SUBJECT: Responds to RAI re proposed amend concerning thermal power update.

Re: Turkey Point Units 3 and 4  
Docket Nos. 50-250 and 50-251  
Request for Additional Information (RAI)  
Proposed License Amendments  
Thermal Power Uprate

Response to NRC Request  
for Additional Information  
Related to Thermal Power Upgrading  
at Turkey Point Units 3 and 4

MAIN STEAM LINE BREAK  
CORE RESPONSE CURVES

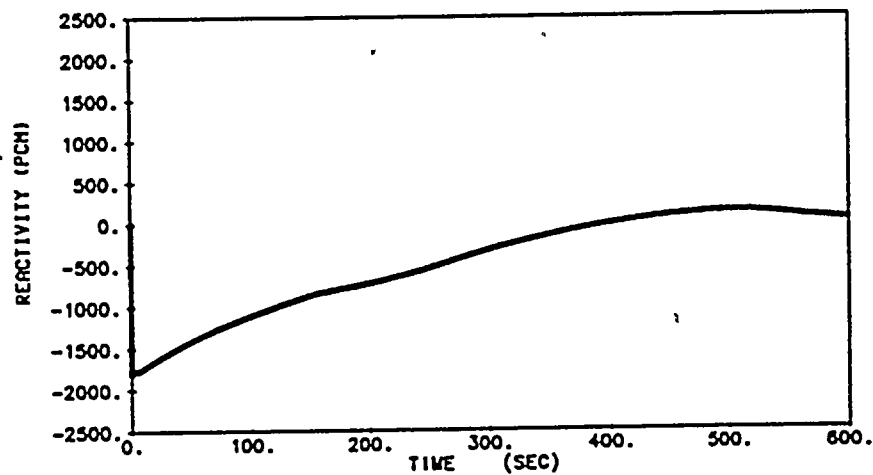
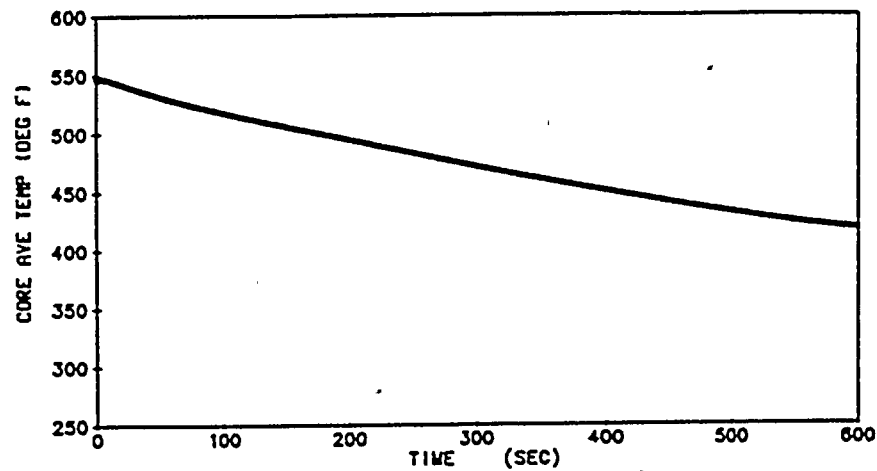
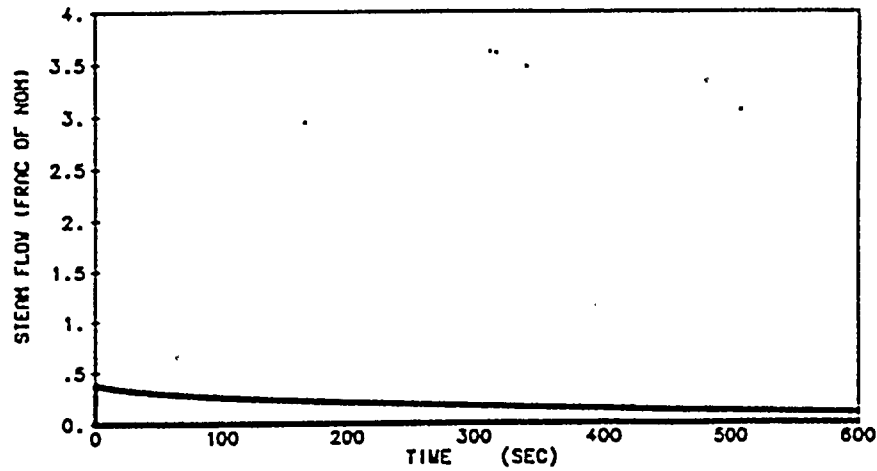
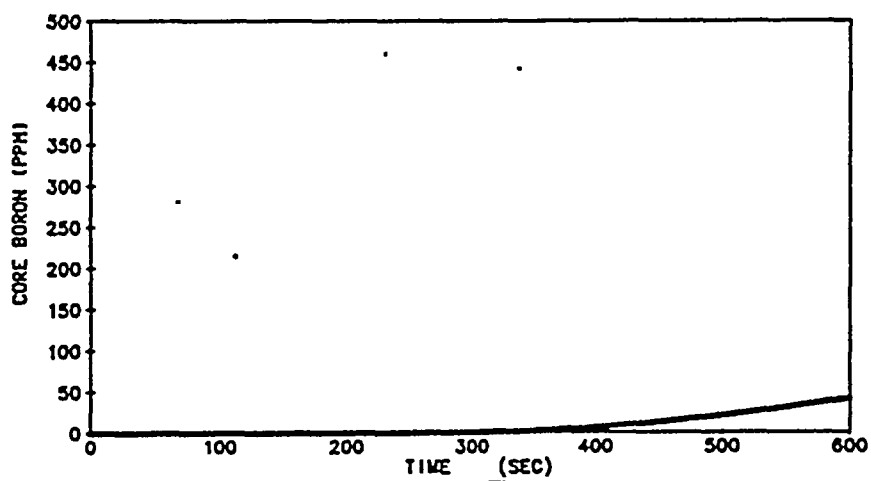
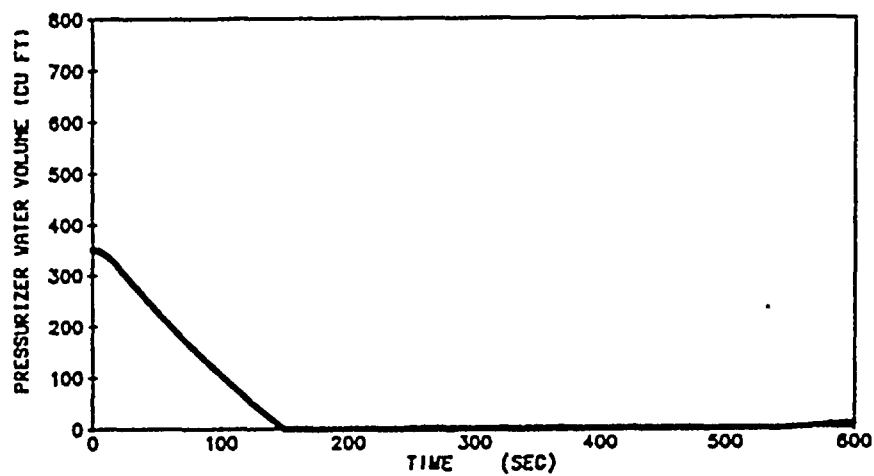
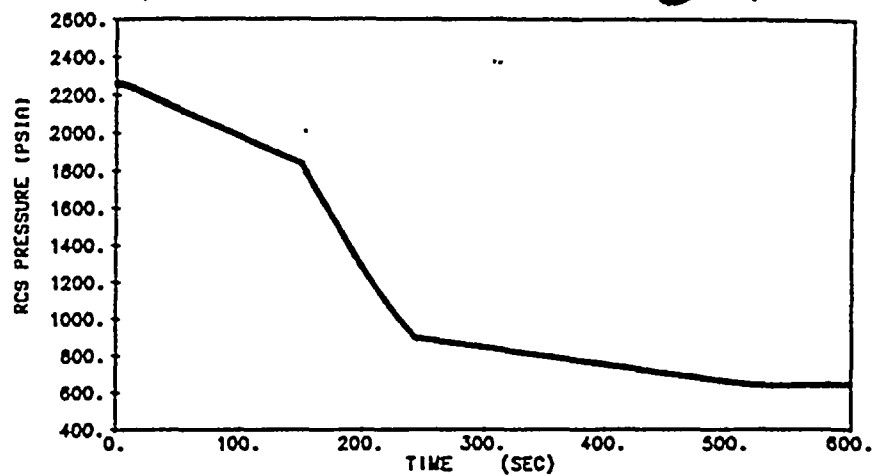
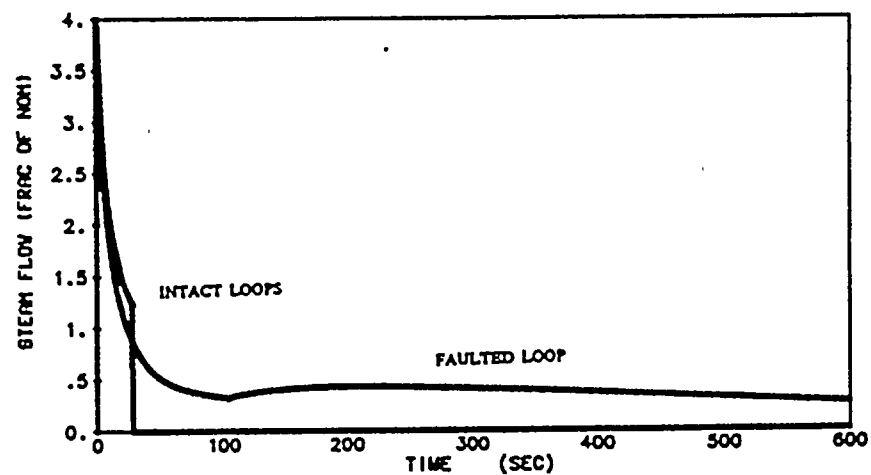
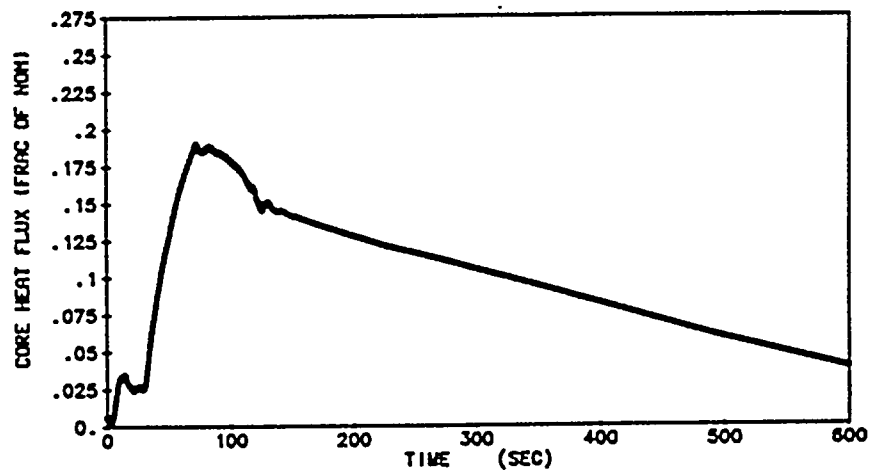
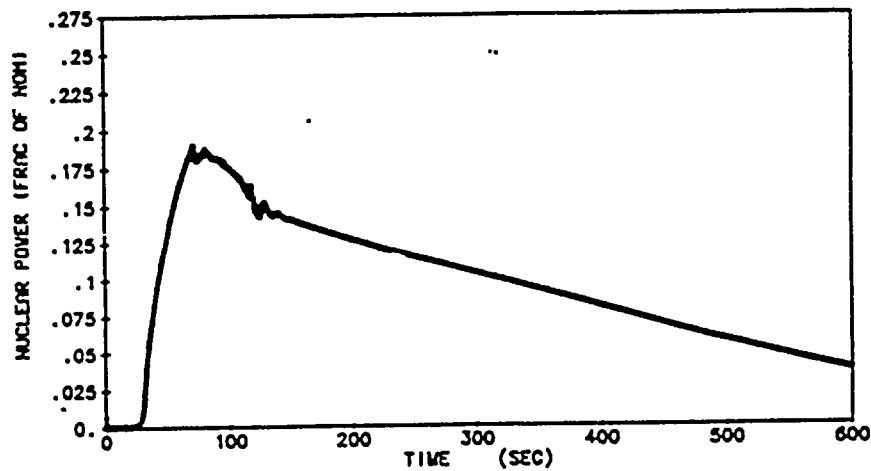
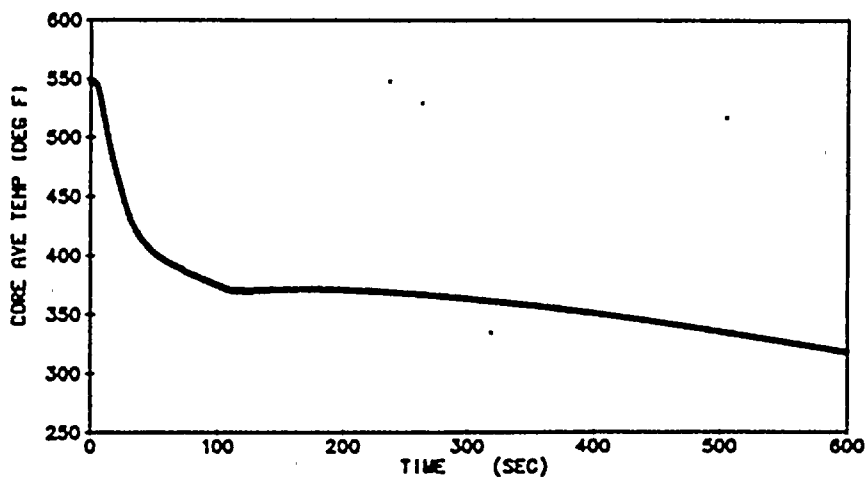
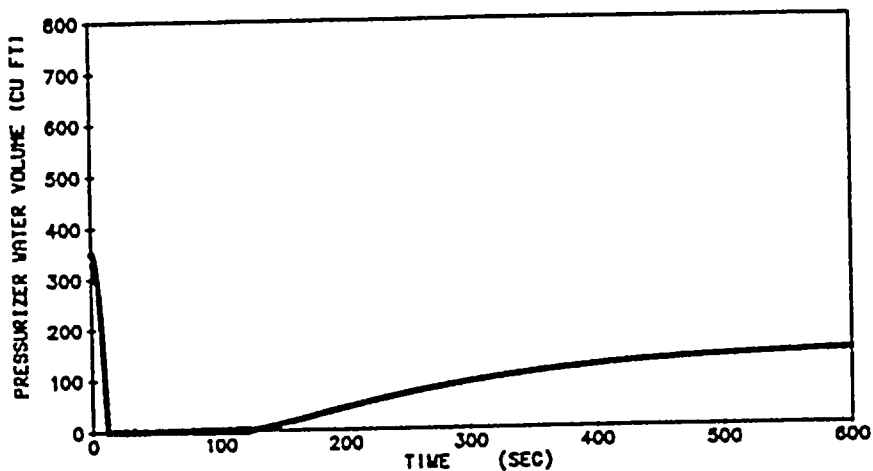
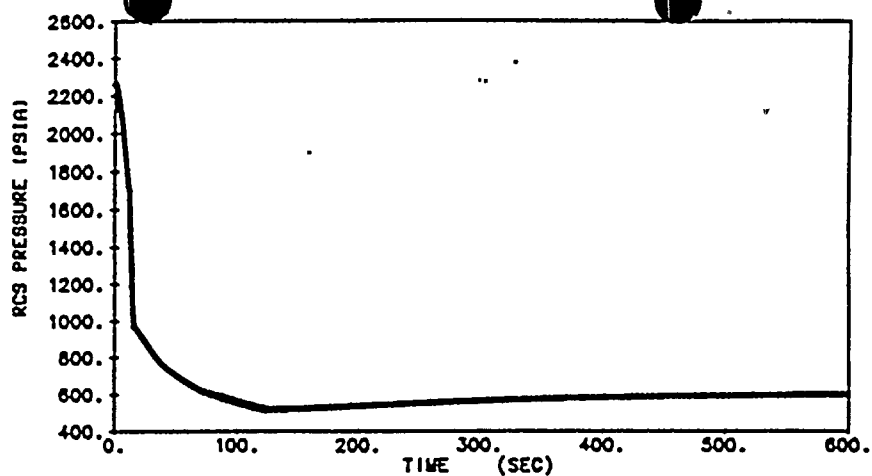
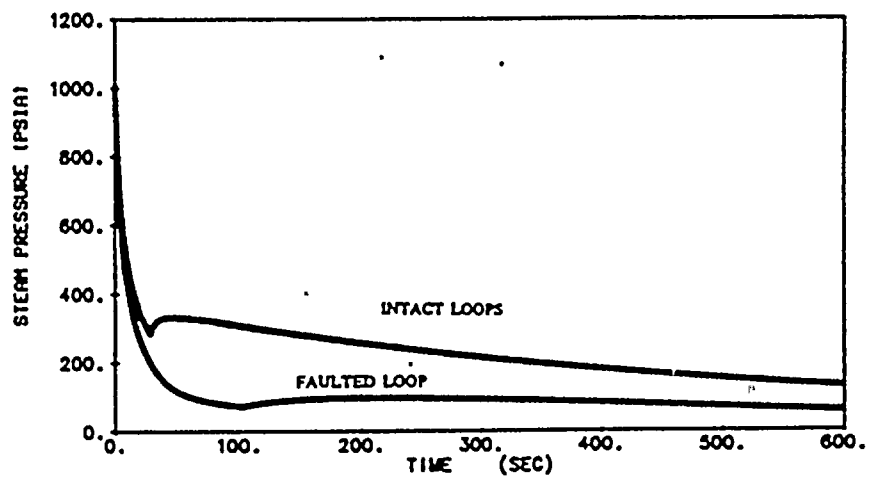
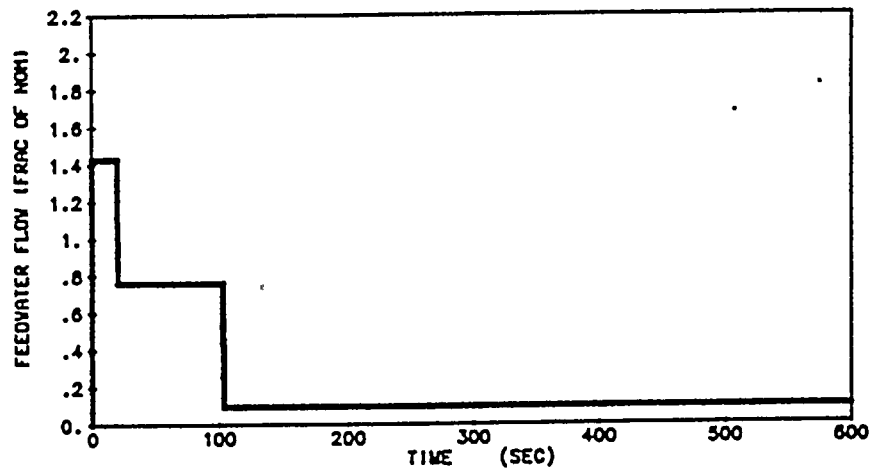
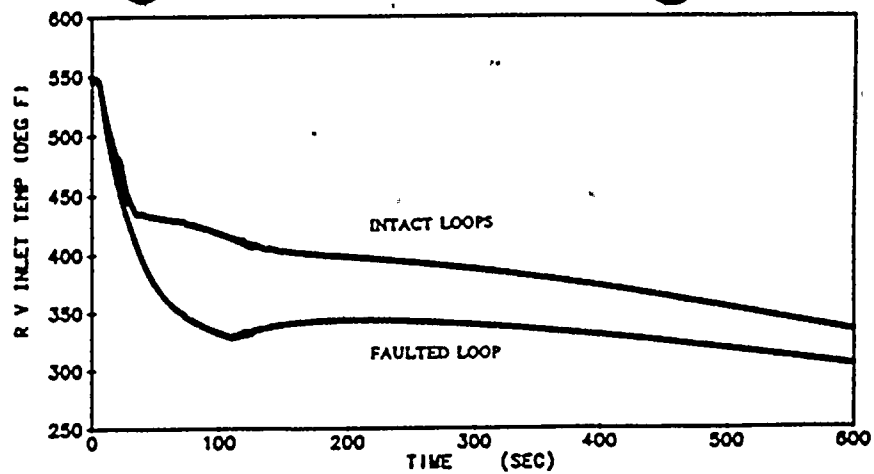
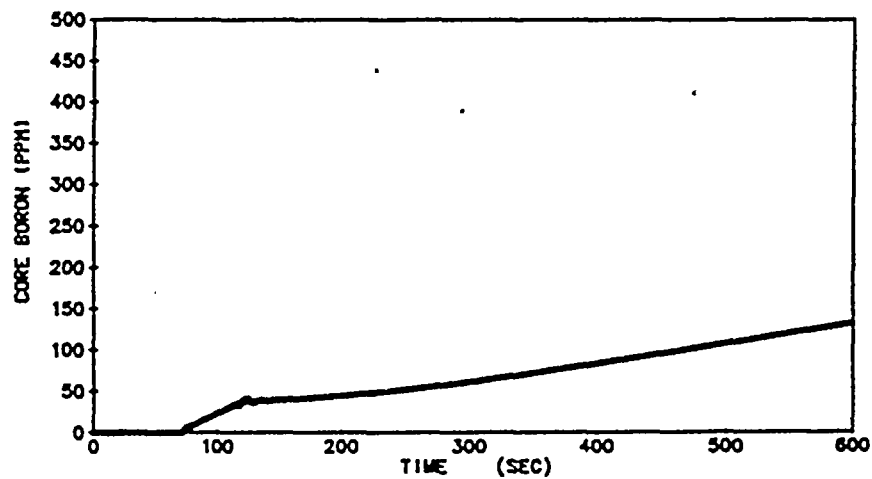
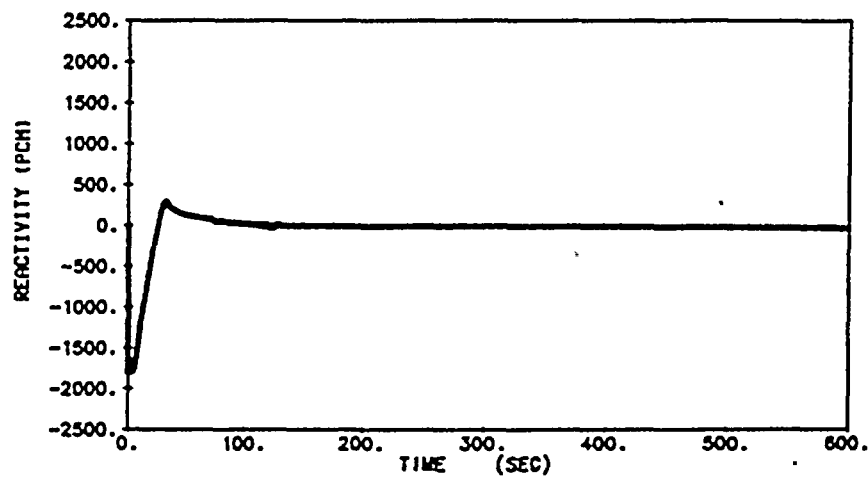
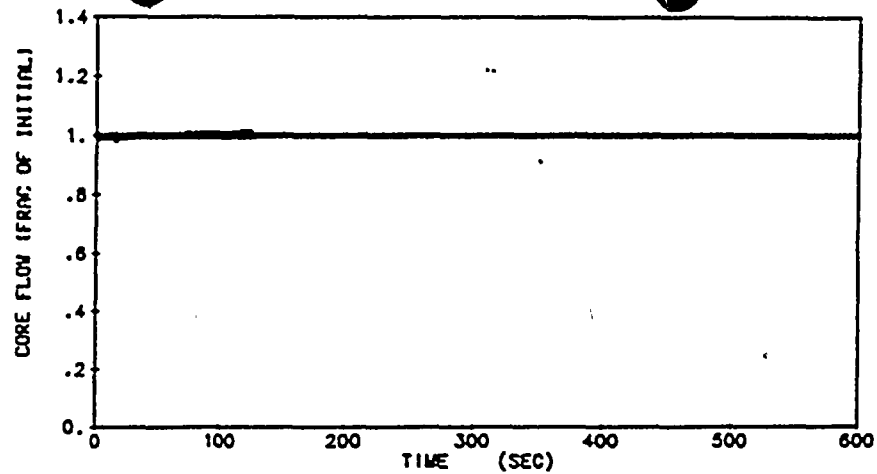
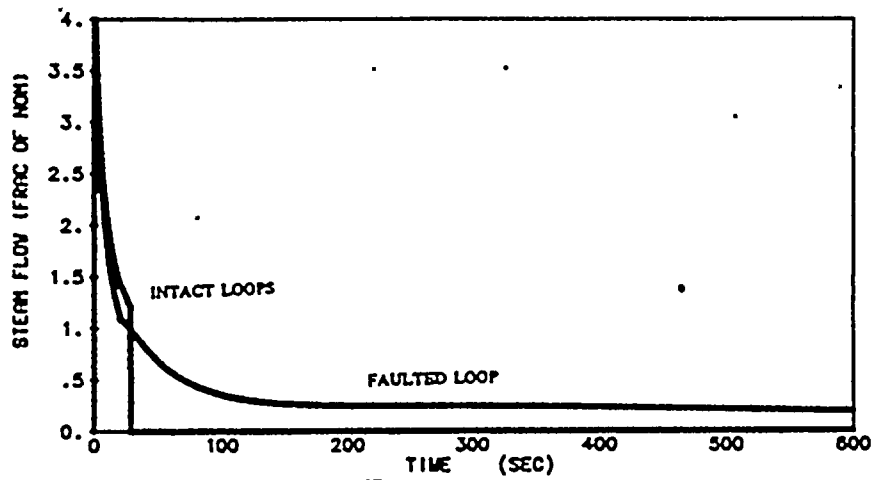
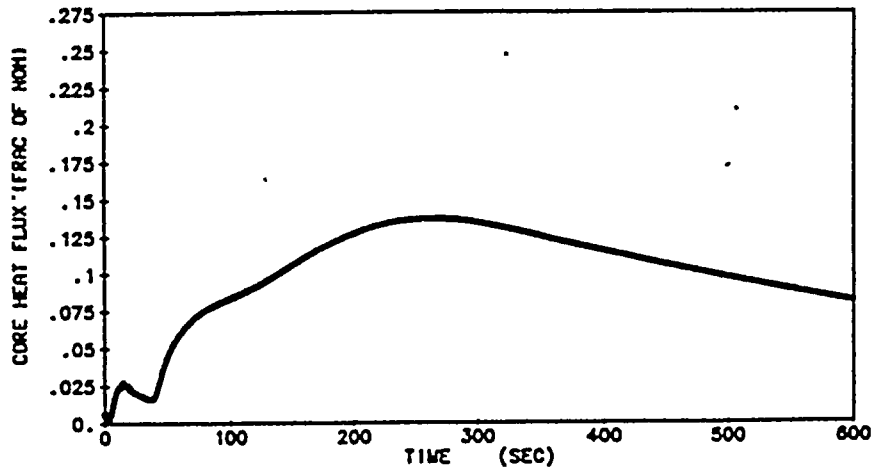
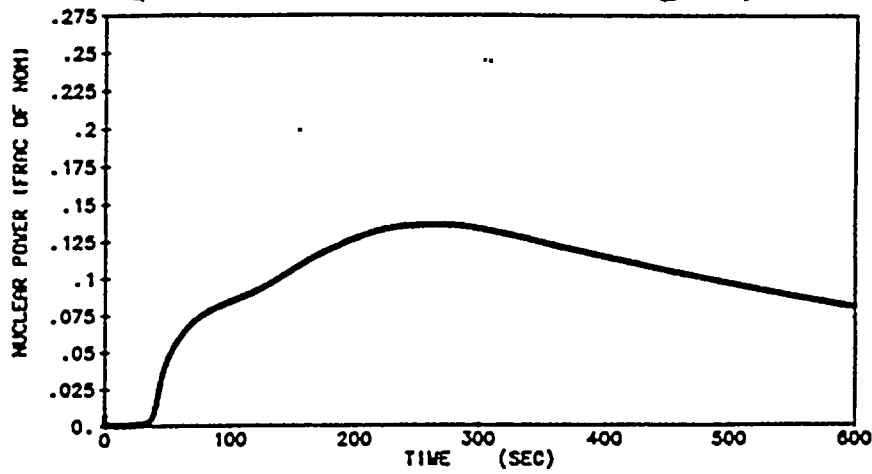
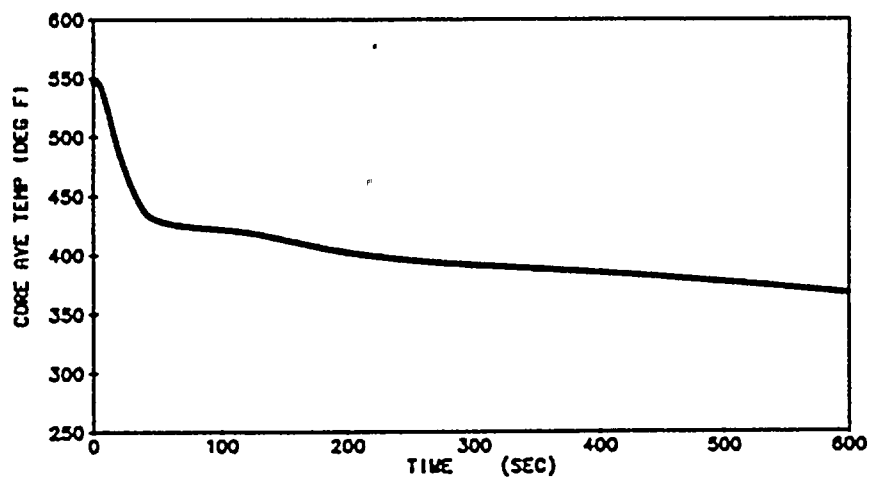
5. "Provide major transient curves for the reanalysis of the postulated main steam line break."

The Main Steam Line Break (MSLB) core response analysis is performed at Hot Zero Power (HZP) conditions, which did not change for the power uprating, and the HZP stuck rod coefficients remained applicable for uprated conditions since these are calculated at HZP and

parameters affecting these coefficients (mainly the moderator density coefficient) have not changed for the power uprating conditions. Therefore, the analysis performed under the RTDP project is not affected by the uprating and the DNBR design basis continues to be met. The curves associated with the proposed UFSAR write-up for the MSLB event are attached.
